Ongoing issues with the Pitt River Bridge Cycling infrastructure (DRAFT, 6 feb 2013)

2. Cycling prohibition: Freemont overpass to Maryhill bypass.

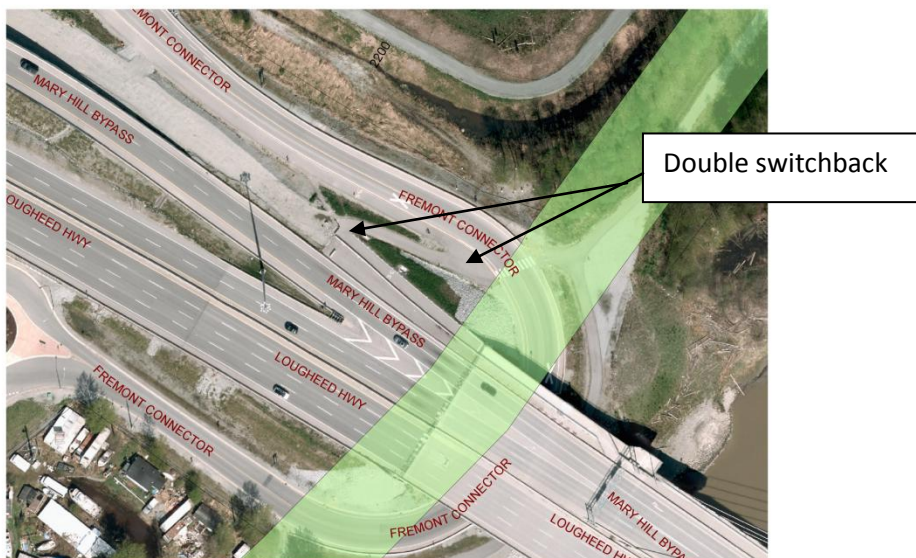
The Freemont overpass provided key access for commuters travelling from PoCo or points east to the Maryhill Bypass. There is a 2m wide shoulder. Cars are travelling at low speeds (50 km/hr posted limit). There is no credible reason for prohibiting cyclists from using this ramp.
